STATE OF MAINE
DEPARTMENT OF TRANSPORTATION
16 STATE HOUSE STATION
AUGUSTA, MAINE 04333-0016

September 23, 2025
Subject: Installation of Road
Weather Information System &
Curve Warning Systems
State WIN: 026630.13
Location: **Calais**
Amendment No. 3

MICRO-CLIMATE ROAD WEATHER INFORMATION STATION WOOD POLE DETAIL
NOT TO SCALE

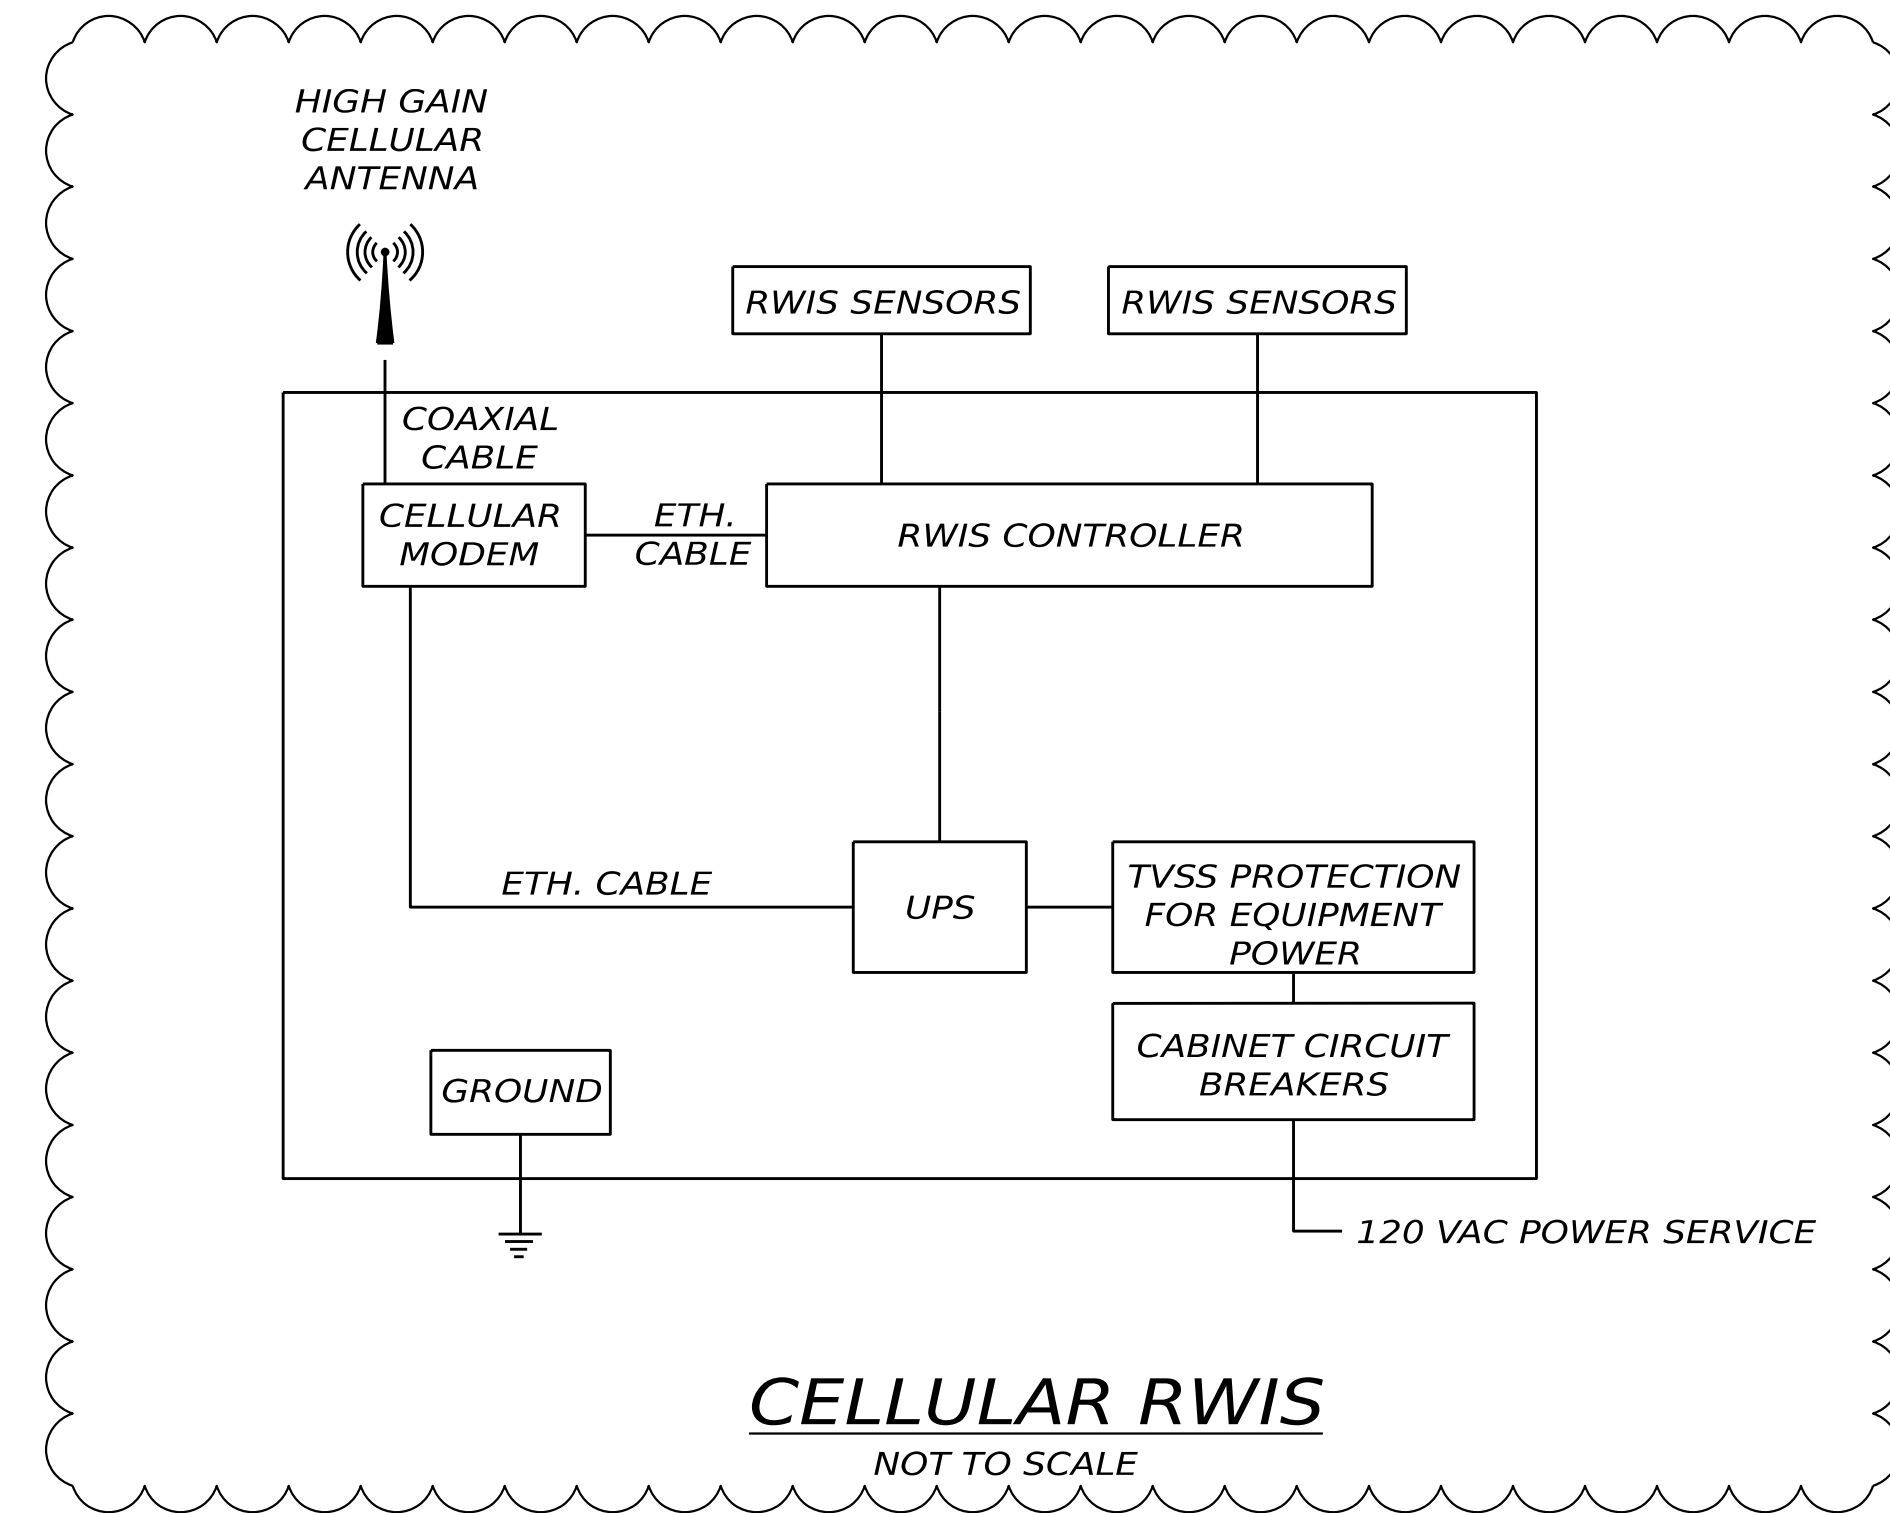
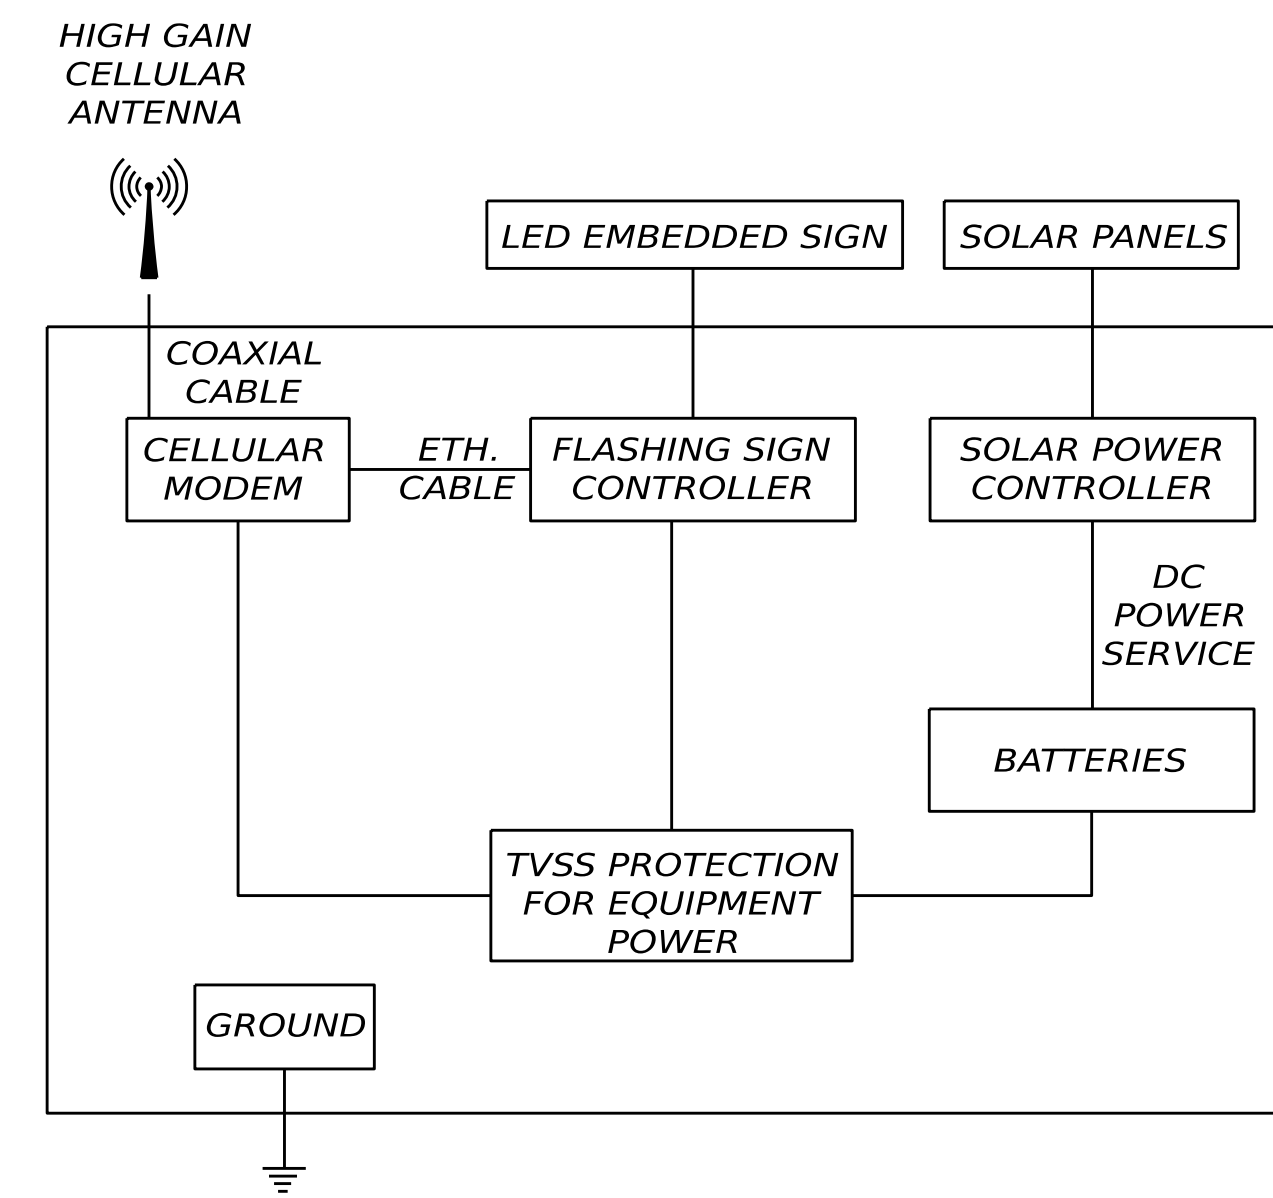
Question: Is a remote power management (RPM) unit required in the cabinets? It is listed on plan sheet 4 of 17, but no mention in the specification or on the schedule of items.

Response: Plan Sheet 4 has been updated to remove reference to a remote power management (RPM) unit. No RPM unit is expected to be provided as part of the Micro-Climate Road Weather Information Station.
